ADMINISTRATIVE AMENDMENT
FILE #09-1083 PROJECT #1002759

*replace restaurant use w/
fire store*

QUAIL RIDGE SHOPPING CENTER	DRAWN BY BJF
	ADMINISTRATIVE AMENDMENT SITE PLAN FOR SUBDIVISION	DATE 1/19/10
		SHEET # C1
JASON M. CASUGA P.E. #19568		JOB # 29044

QUAIL RIDGE SHOPPING CENTER ADMINISTRATIVE AMENDMENT SITE PLAN FOR BUILDING PERMIT	DRAWN BY BJF DATE 1/19/10 2944-SPB-AA
	TIERRA WEST, LLC 5571 MIDWAY PARK PLACE NE ALBUQUERQUE, NM 87109 (505)858-3100 www.tierrawestllc.com	SHEET # C3 JOB # 29044

QUAIL RIDGE SHOPPING CENTER
ADMINISTRATIVE ADMMENDMENT
SITE PLAN FOR SUBDIVISION

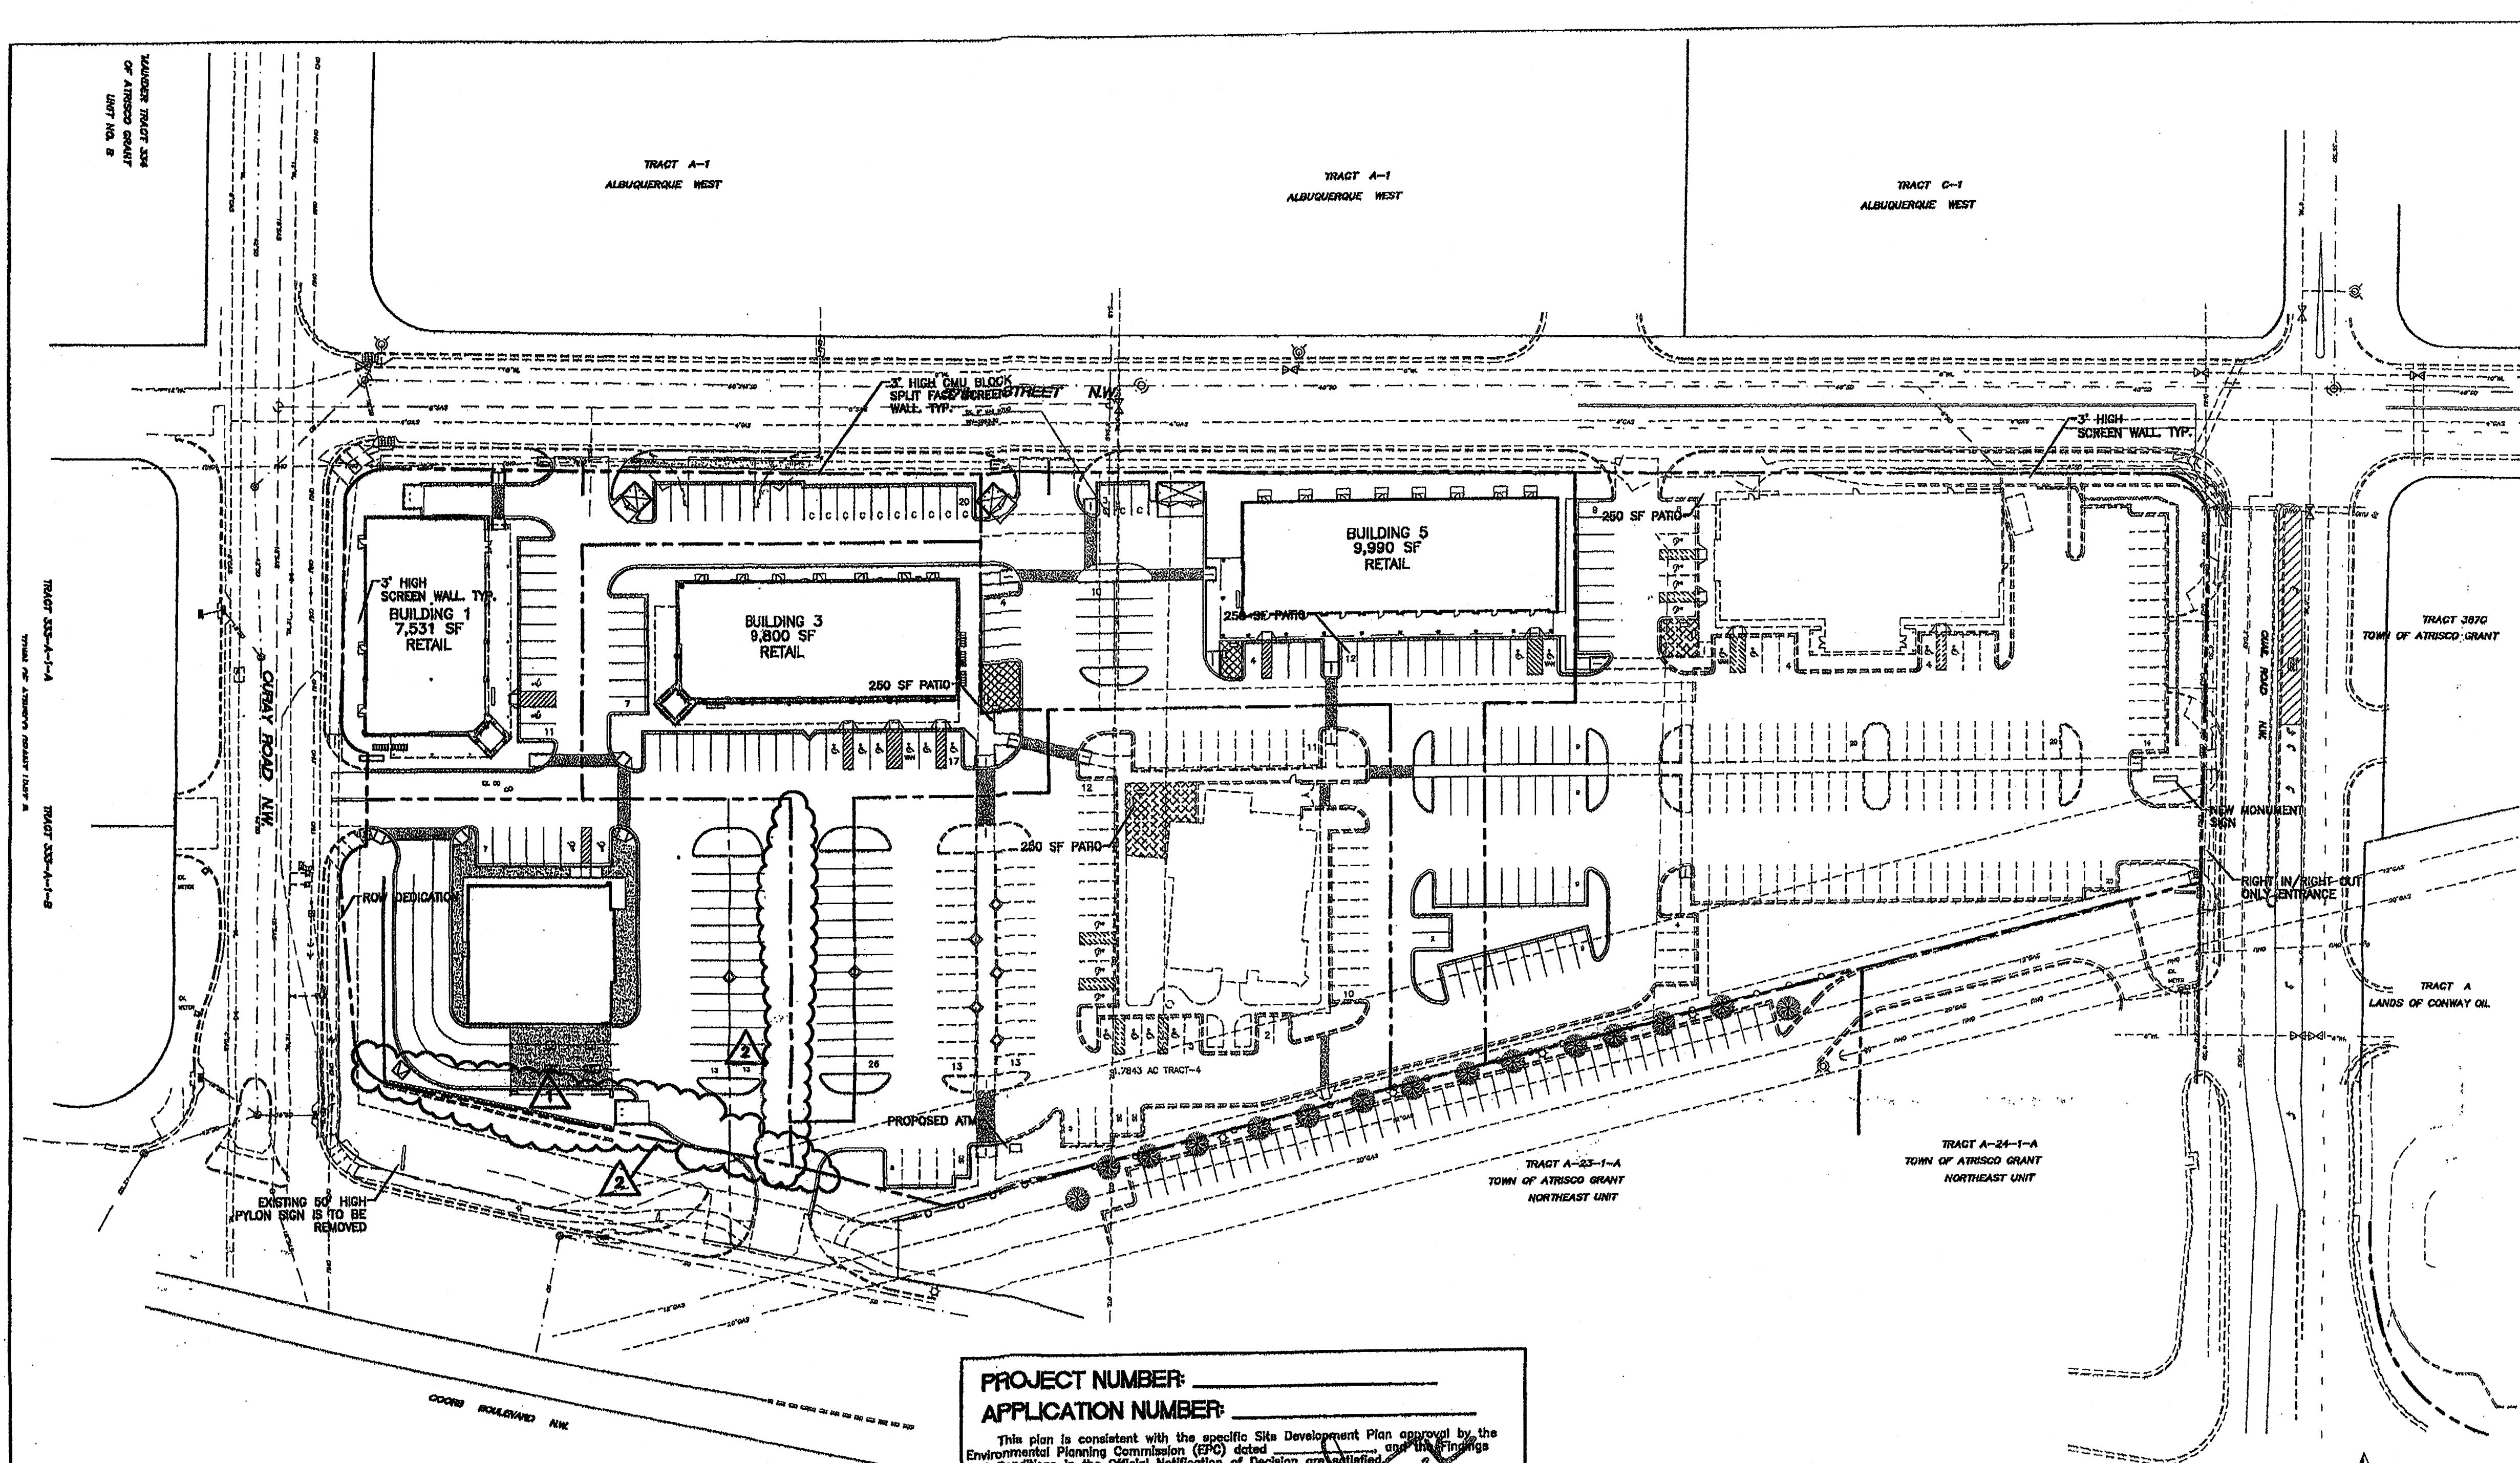
ADMINISTRATIVE AMENDMENT
 File #05A-025 Project # 10024679
 Amend property lines to extend along Coors Blvd parking way to the entire site
 Approved by: _____
 DATE: _____

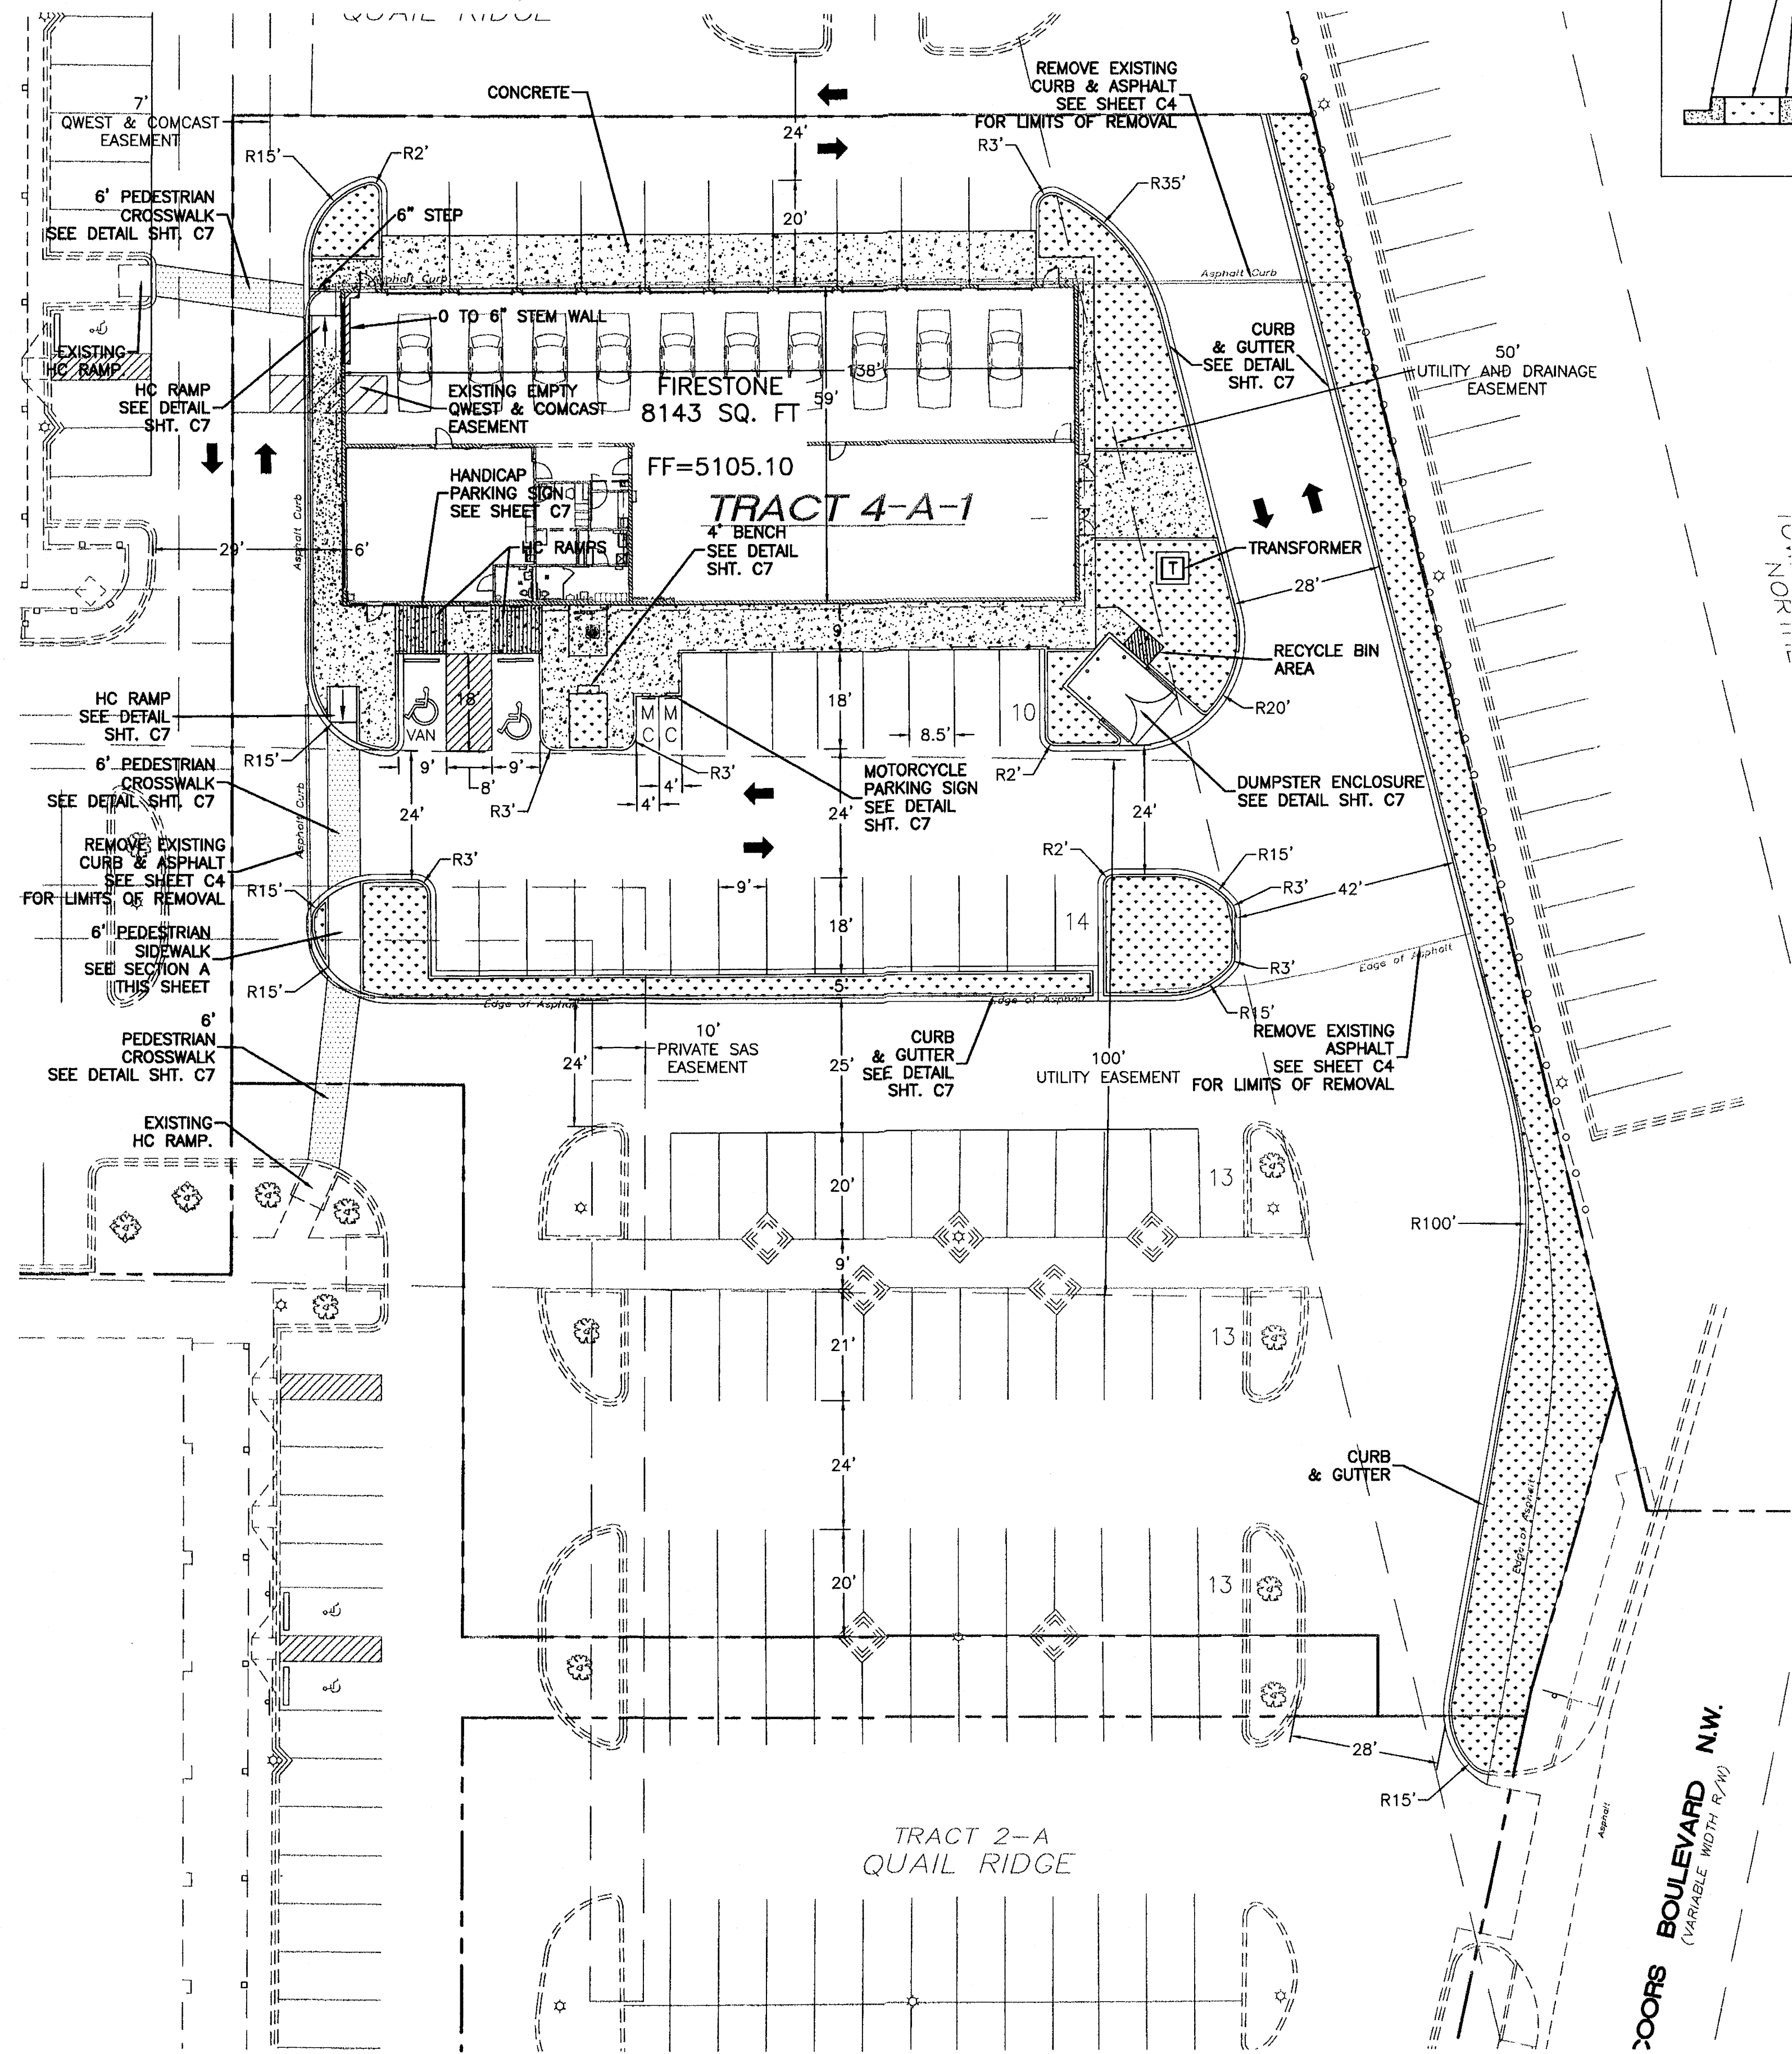
ADMINISTRATIVE AMENDMENT
FILE #09-1018 PROJECT #1002759
replace restaurant use w/
tire store
Chamone 2/11/10
APPROVED BY DATE
